RE: MOUNT PLEASANT OPTIMISATION PROJECT – REQUEST FOR INFORMATION

Further to the Department of Planning, Infrastructure and Environment (DPIE) request for additional information regarding the Mount Pleasant Optimisation Project (the Project) (letter dated 27 August 2021), please find attached MACH Energy's (MACH's) responses enclosed in Attachment A.

Attachment A

DPIE Advice and MACH's Responses

Graph 1 – Workforce Profile for The Project and Currently Approved Mount Pleasant Operation.

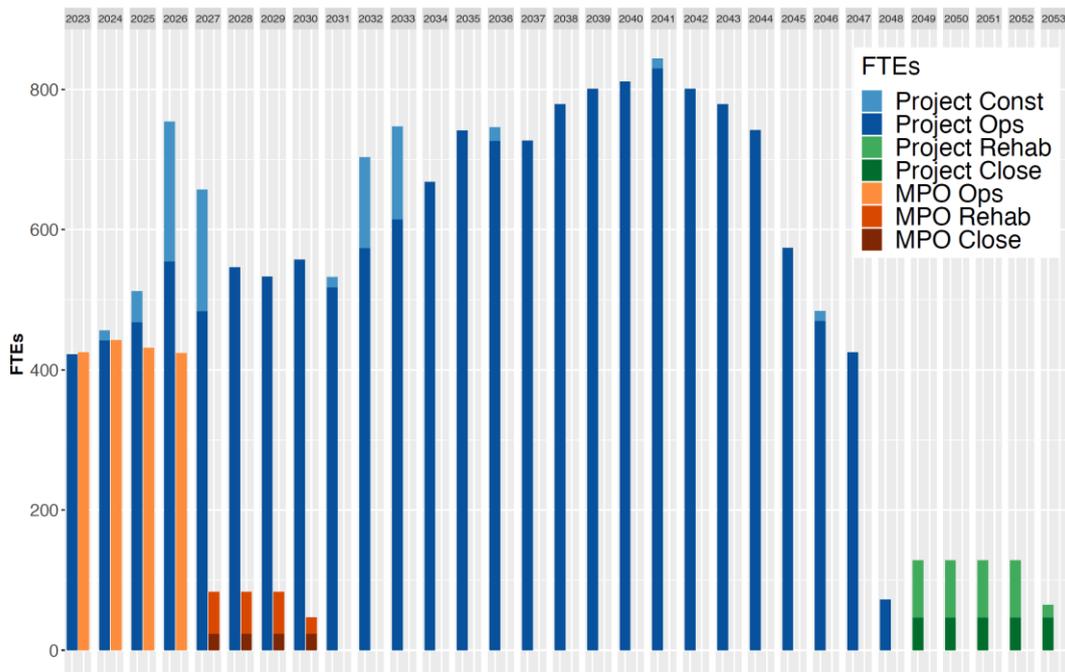
2. *Please provide clarification regarding projected workforce numbers for the project throughout the EIS. Please clarify:*
 - a. *the total average additional employment (full-time equivalent positions) for:*
 - *project construction over the life of the project; and*
 - *project operations over the life of the project.*
 - b. *the maximum work force numbers (full-time equivalent positions) for:*
 - *project construction; and*
 - *project operations.*

The estimated annual average workforce on a full-time equivalent (FTE) basis for the currently approved Mount Pleasant Operation and the Project are included in Table 1 and Graph 1 below, reproduced from Appendix O of the Project EIS. The additional workforce to the approved Mount Pleasant Operation can be derived from Table 1 by comparing the two workforce profiles.

The Project annual average FTE construction (2026) and operational (2041) workforce peaks would be approximately 200 and 830 people, respectively (Graph 1).

Figure 1

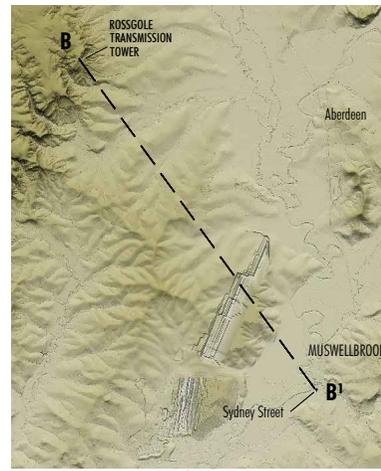
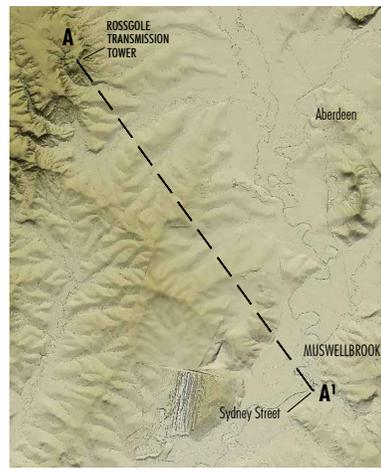
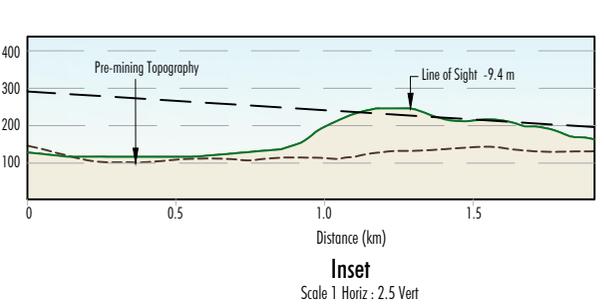
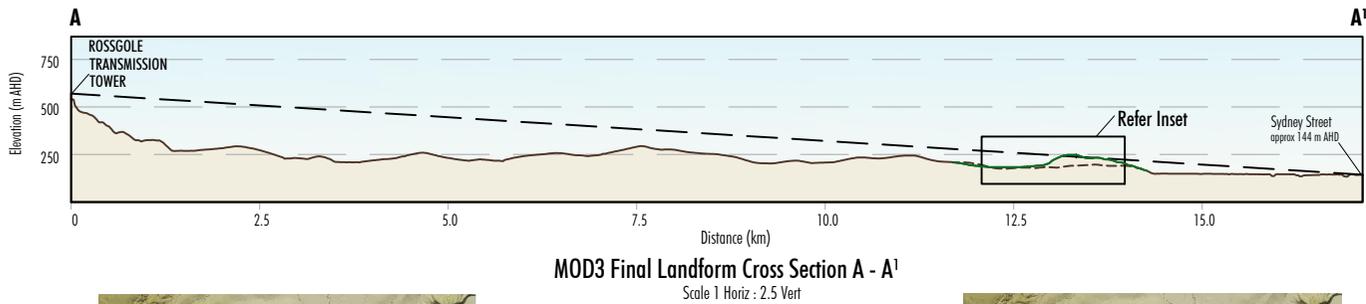
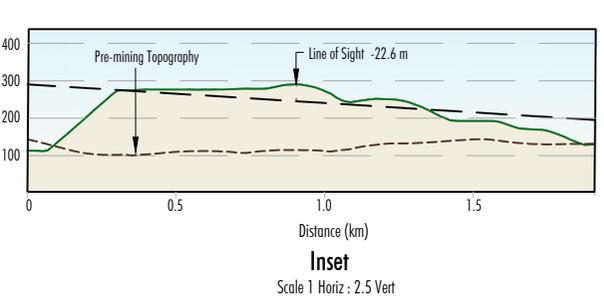
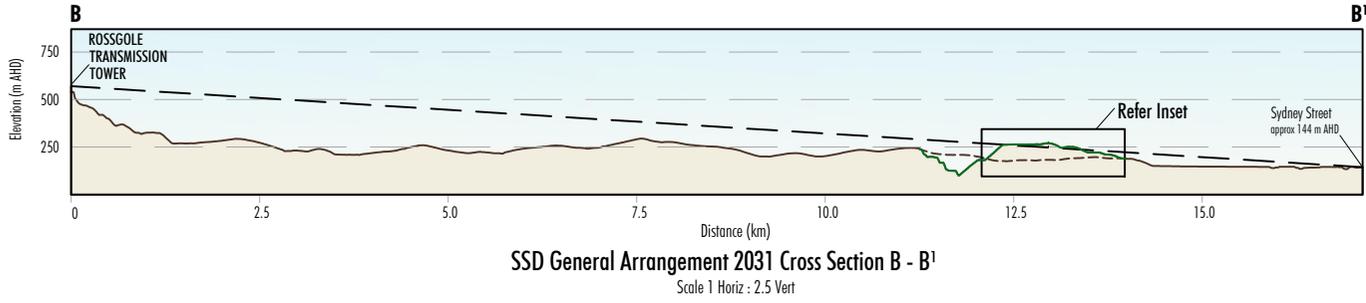
3. *Regarding the community and Muswellbrook Council's concerns with the Rossgole transmission facilities, please clarify if the increased elevation of the project's integrated waste rock emplacement would impact upon the ability of the tower to transmit radio, television and emergency broadcasts to Muswellbrook.*

As the approved Mount Pleasant Operation Eastern Out-of-Pit Emplacement landform rises in elevation, it would begin to obscure line of sight between some facilities on the Rossgole Transmission tower and lower residential areas of Muswellbrook. Figure 1 indicates that the approved mine landforms would be approximately 10 metres (m) above line of sight to Sydney Street at this location by 2026. As the Project integrated waste rock emplacement landform would increase in elevation relative to the approved Modification 3 final landform, any transmission signal effects that could arise from the approved Mount Pleasant Operation landform are likely to be exacerbated by the Project. For comparative purposes, Figure 1 illustrates the same cross-section in 2031 when the Project landforms would be approximately 23 m above line of sight.

Based on this analysis, MACH anticipates that some measurable terrain transmission effects could well arise over the life of the Mount Pleasant Operation for Rossgole Tower, depending on the transmission technology and location of alternative facilities being employed at the time. Therefore, as stated in the Submissions Report, MACH would not object to a condition requiring make-good provisions (e.g. such as raising an existing tower or construction of an additional transmission station), should such an adverse impact be demonstrated to occur.

Figure 2

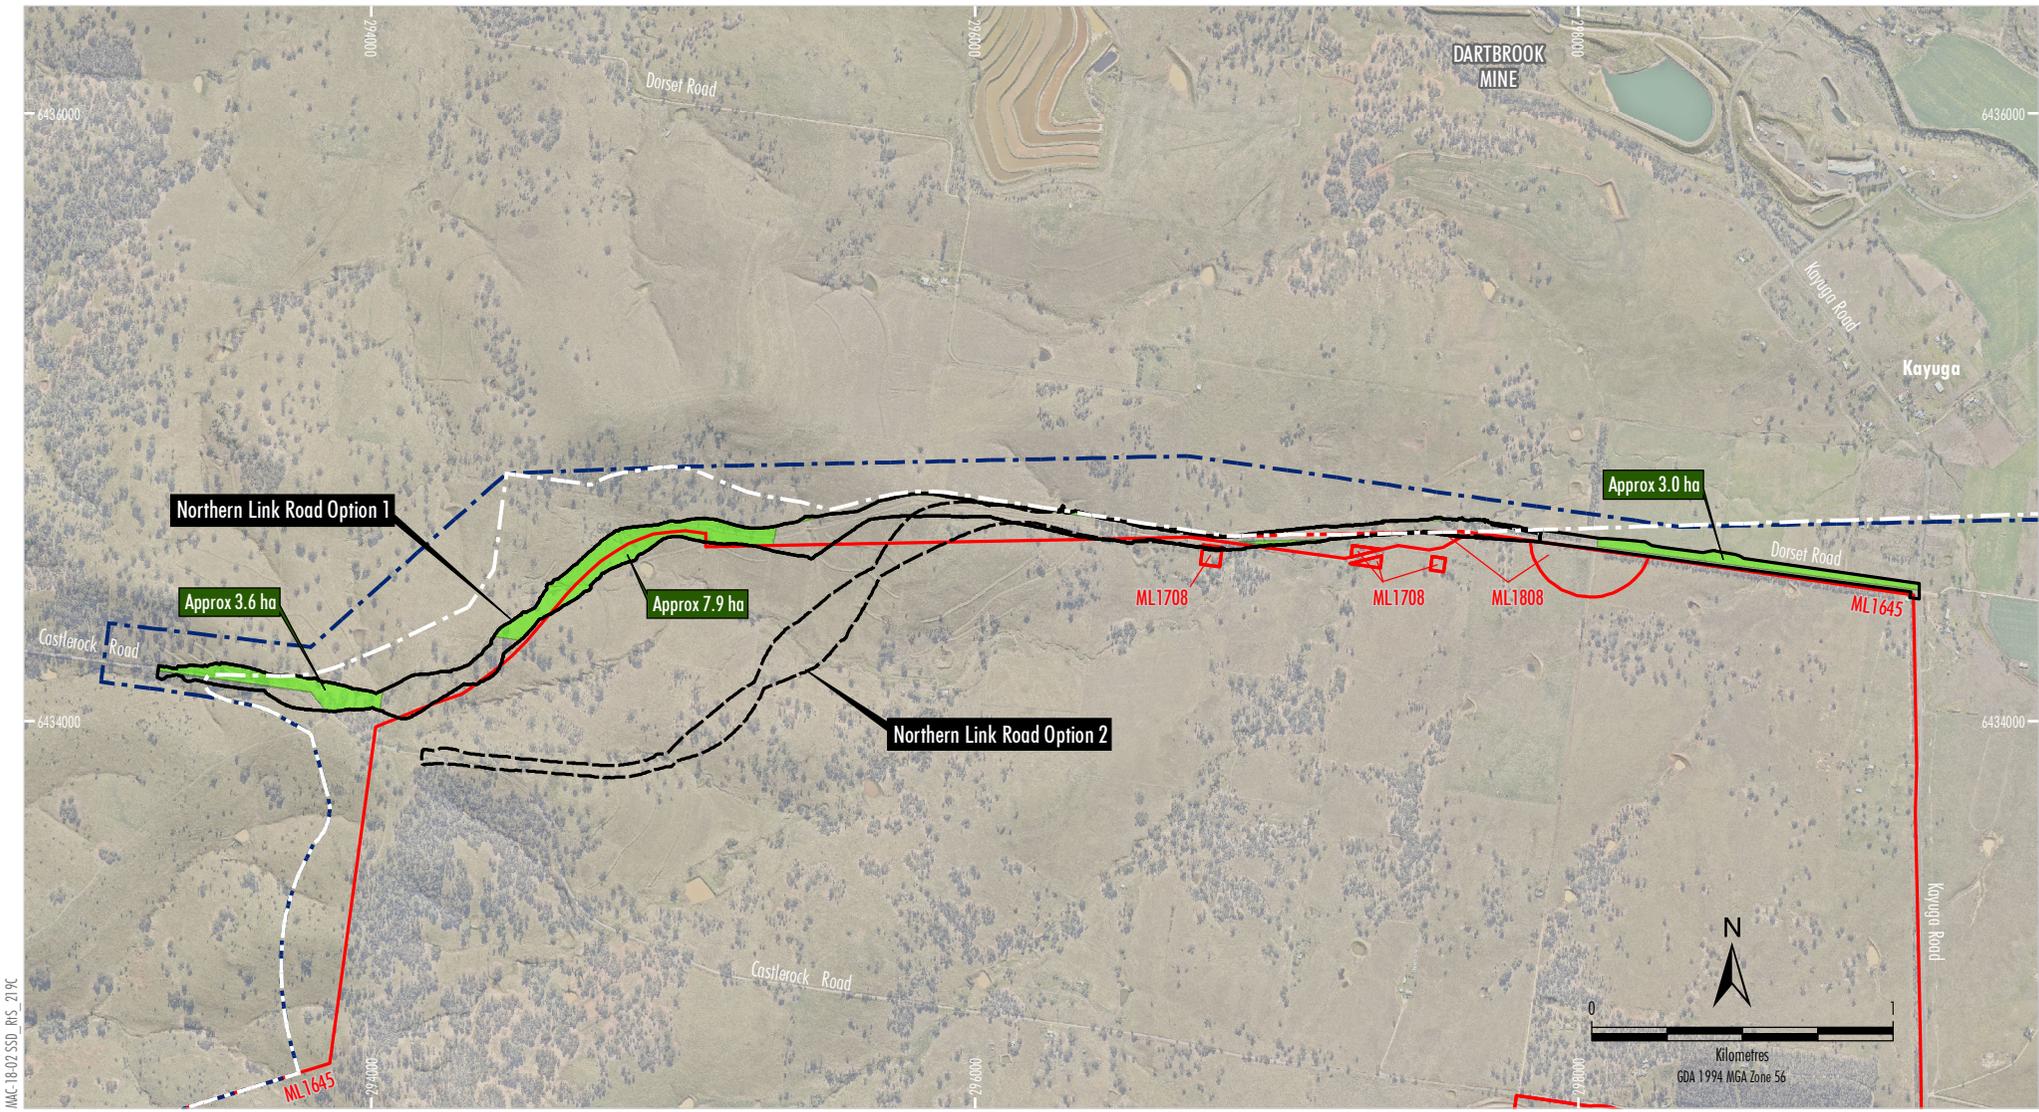
5. *For the purposes of clarifying the area of land that would be subject to future Aboriginal Heritage surveys, please provide:*
 - a. *a detailed figure showing the 13.8 hectares of unsurveyed land within the proposed Northern Link Road area. Please include the Development Consent approval boundary (DA 92/97), the mining lease boundaries (ML1645, ML1708, ML1808, ML1709, ML1750, ML1713) and the project disturbance area boundaries (SSD 10418); and*

Figure 2 shows the small residual unsurveyed area within the revised Northern Link Road Options 1 and 2 alignments (up to approximately 15 hectares [ha] inclusive of Option 1). The unsurveyed area within the revised Northern Link Road alignment has been updated to reflect the minor amendments made to the Project footprint subsequent to completion of the Project Aboriginal Cultural Heritage Assessment (ACHA) report (Kuskie, 2020a)² (Appendix G of the Project EIS). The potential Aboriginal cultural heritage implications of these minor amendments were assessed in the Addendum Report (Kuskie, 2020b)³ (Appendix G of the Project EIS).

Figure 3

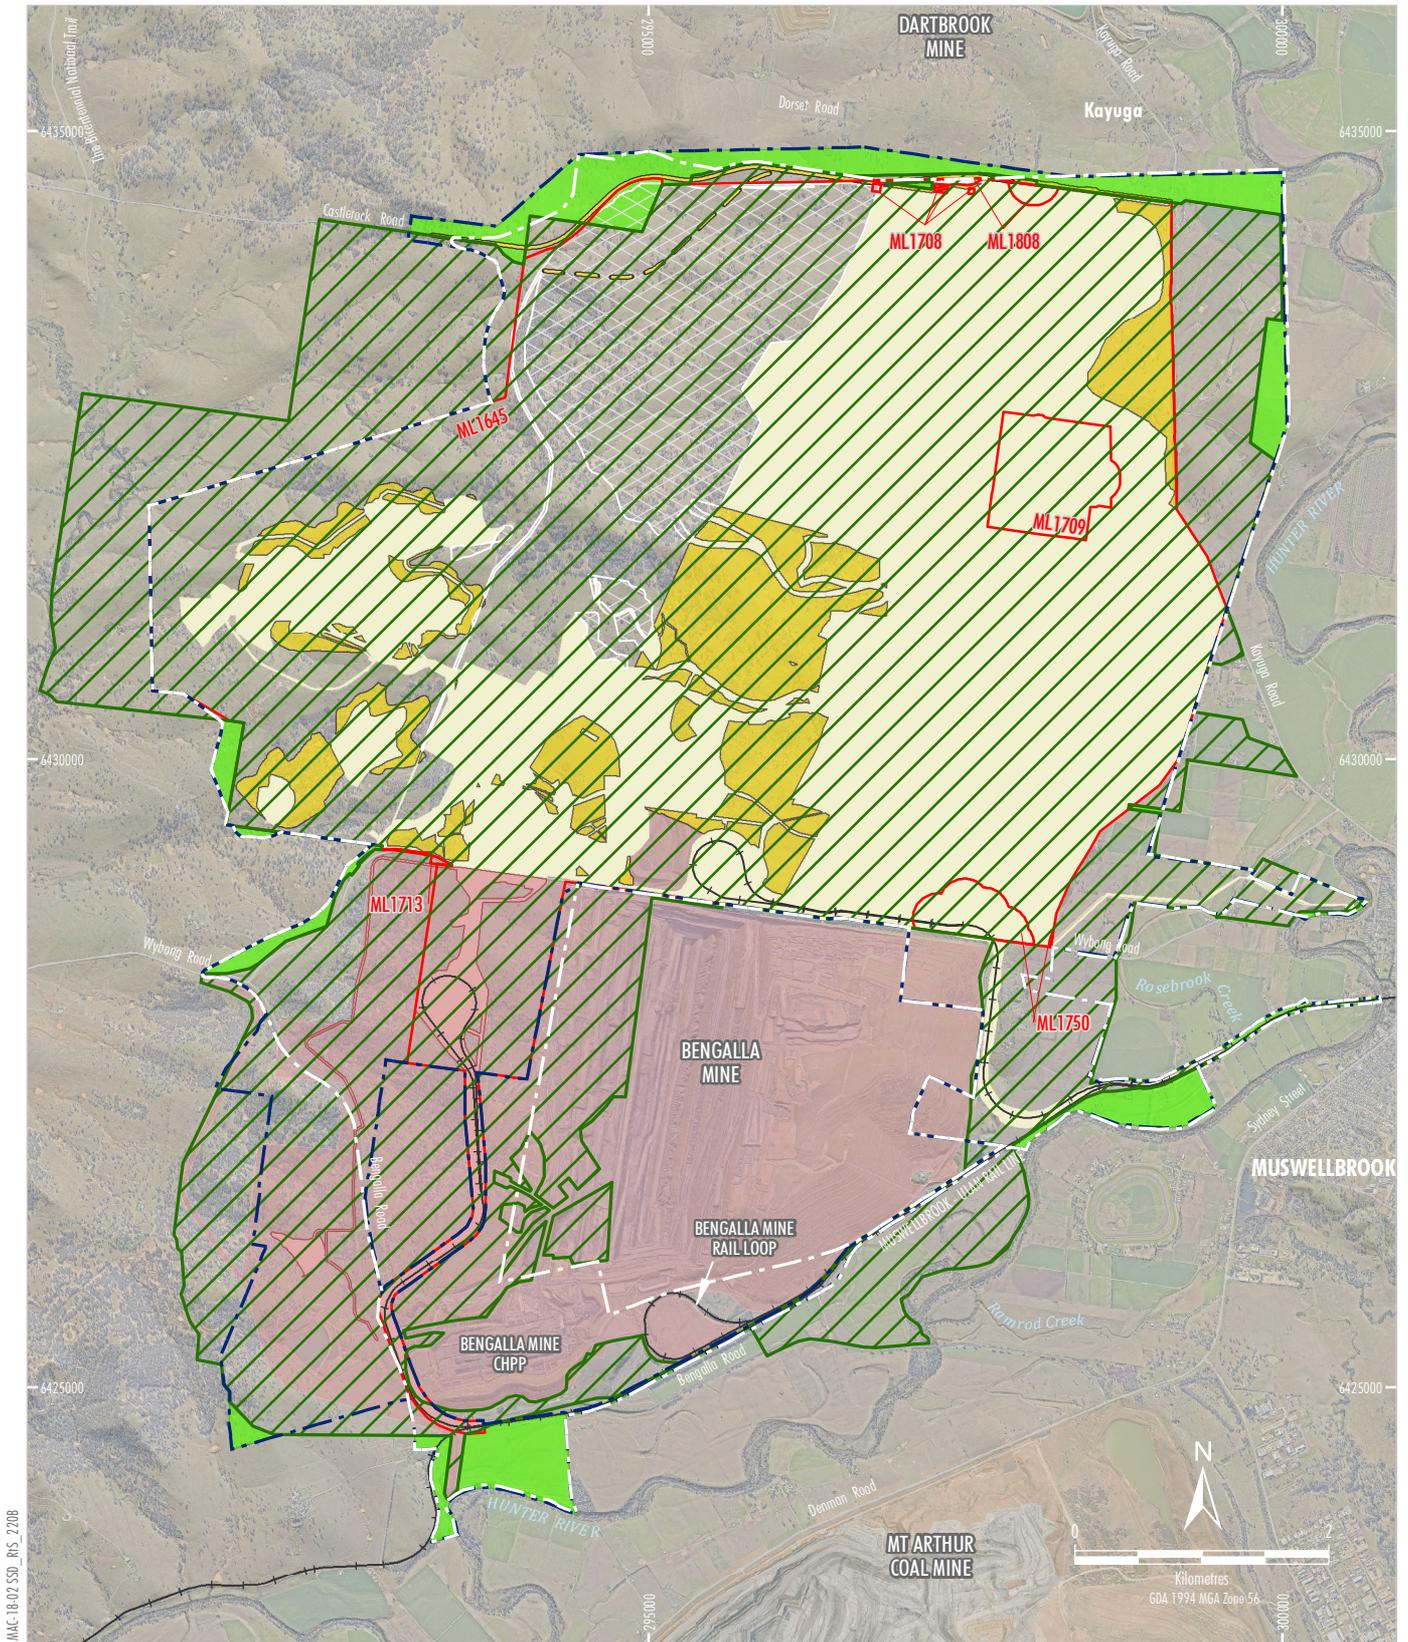
- b. *a detailed figure showing the total land that remains unsurveyed within the Development Consent approval boundary (DA 92/97), the mining lease boundaries (ML1645, ML1708, ML1808, ML1709, ML1750, ML1713) and the project disturbance area boundaries (SSD 10418).*

Figure 3 shows the area within the Project Development Consent Application Area (SSD 10418) where no evidence of previous Aboriginal heritage survey is available. Figures 4a and 4b show the 15 'SSD Zones' discussed in the ACHA within the Development Consent Application Area (SSD 10418).
